STAFF RECOMMENDATION
2509 Belmont Boulevard
May 17, 2017

Application: New construction – outbuilding (detached accessory dwelling unit); Setback determination

Description of Project: Application is to construct a detached accessory dwelling unit (DADU) at the rear of the lot. The structure requires a rear setback determination from twenty feet (20') to ten feet (10').

Site Plan Layout

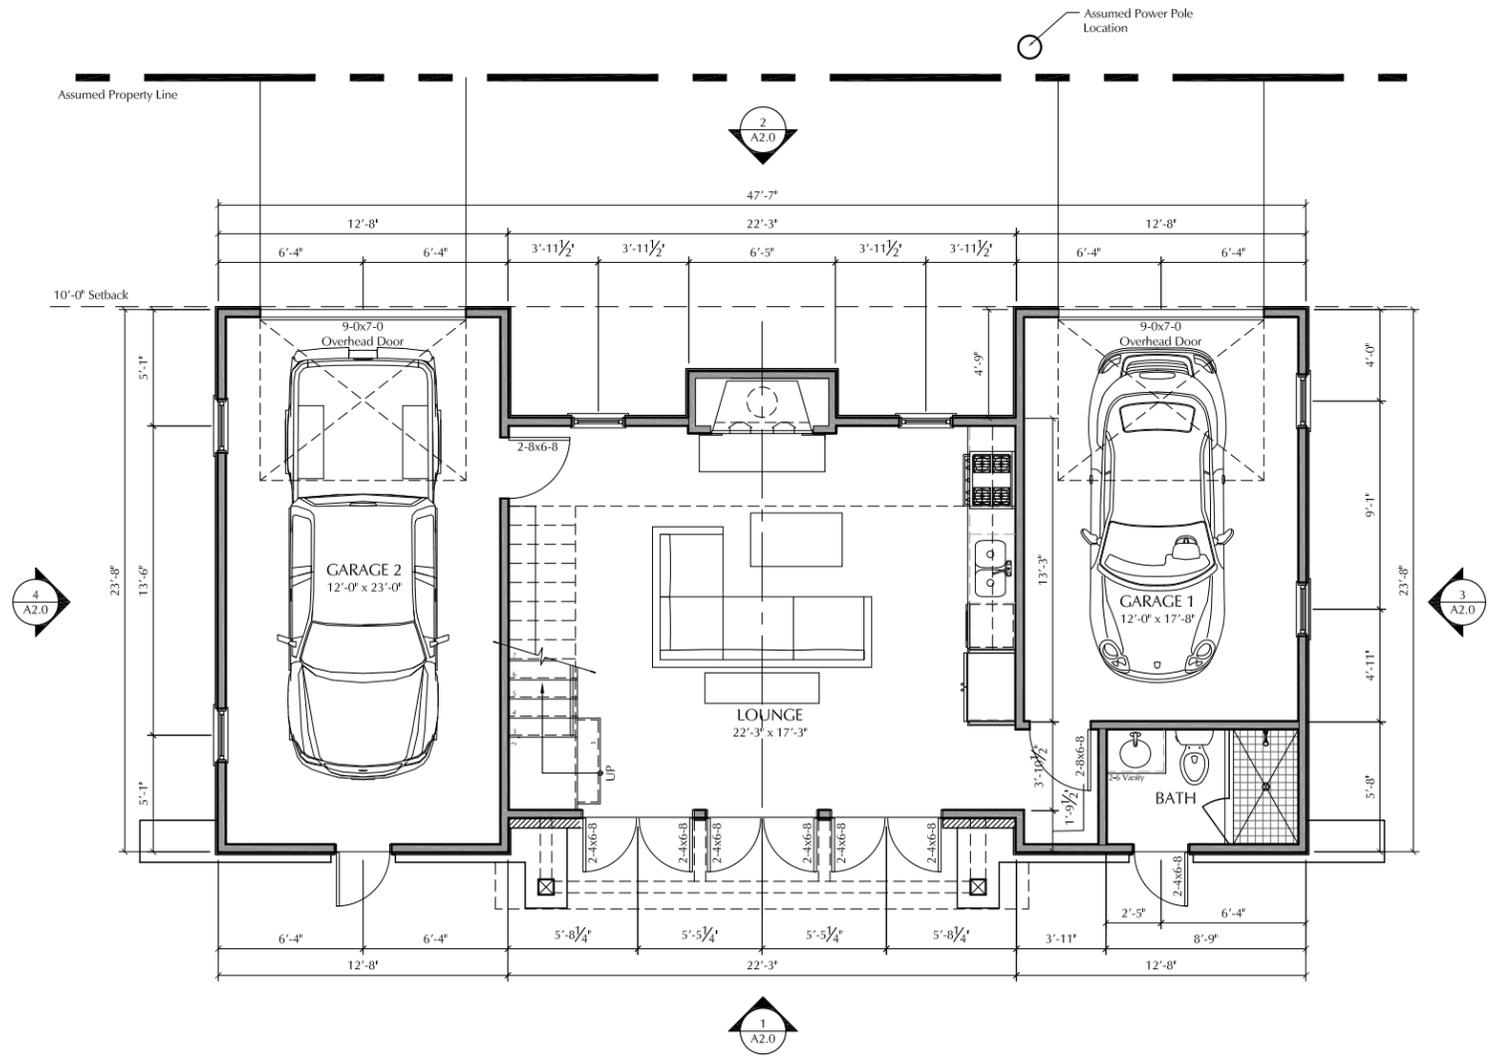
The applicant proposes to locate the building at the rear of the lot, with a rear setback of ten feet (10'). This setback is typical of the locations of outbuilding historically and meets the design guidelines, but is shorter than the twenty foot (20') setback requirement under the base zoning. Staff finds the proposed location to be appropriate and to meet section III.B.1.i.2 of the design guidelines. The side setbacks also meet the design guidelines and zoning requirements.

Drawings:
Elevations
Date:
05.01.17

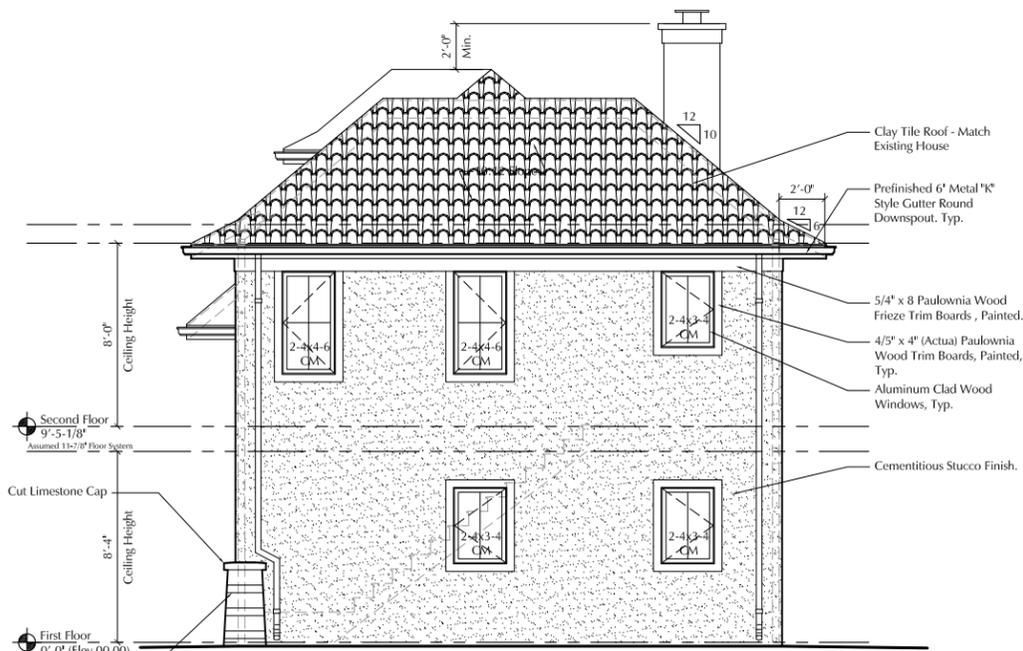
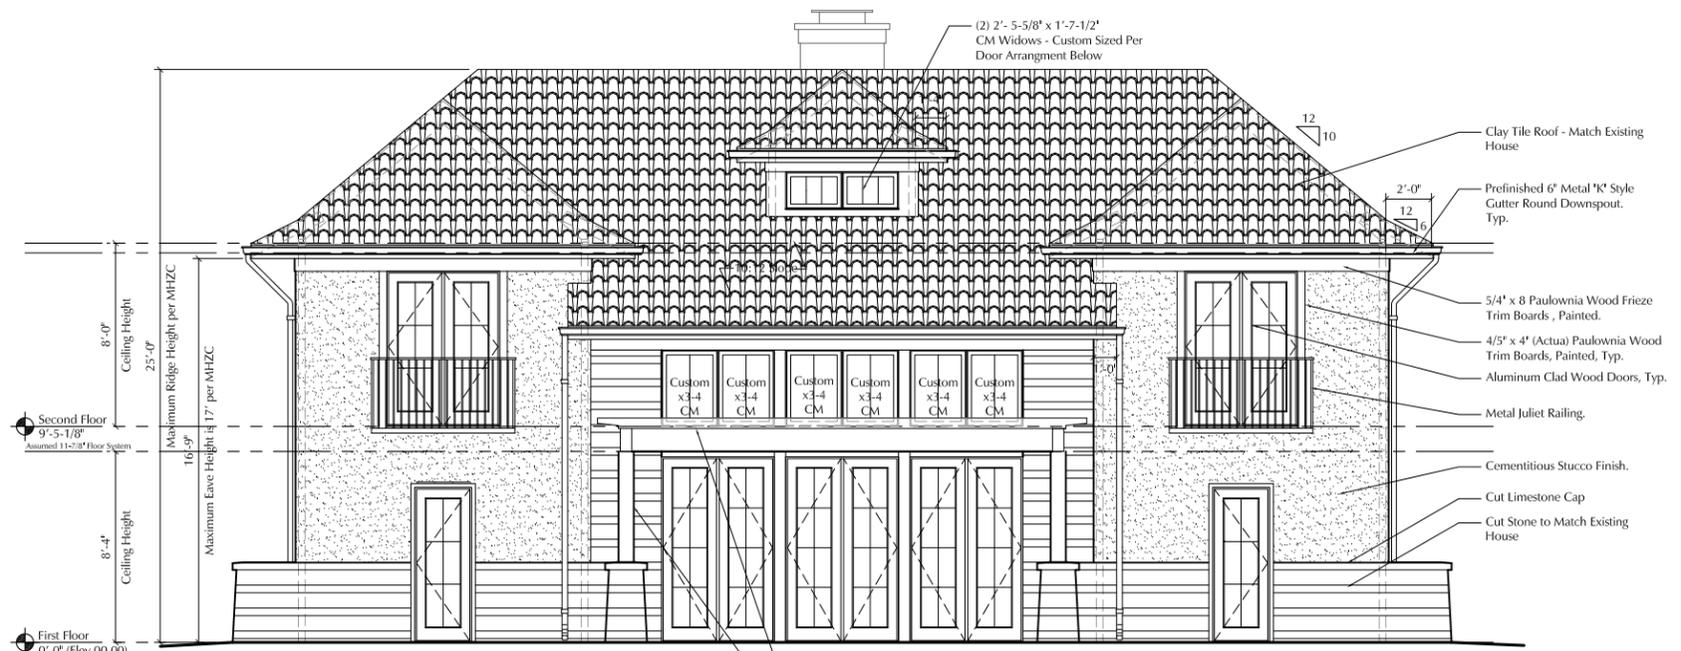
Design Standards: The materials, proportions, and overall character of the accessory structure will be similar to the historic house. Its roof form and pitch will match that of the house, and the materials will not contrast greatly with the primary structure. The window proportions and locations are compatible with those of outbuildings historically. Staff finds the design of the proposed outbuilding to meet section III.B.1.i.1 of the design guidelines

With that condition that the window and door selections are approved by MHZC Staff prior to purchase and installation, the project will meet section III.B.2.h of the design guidelines.

- The window and door selections are approved by MHZC Staff prior to purchase and installation; and
- A restrictive covenant is filed prior to issuance of a permit.
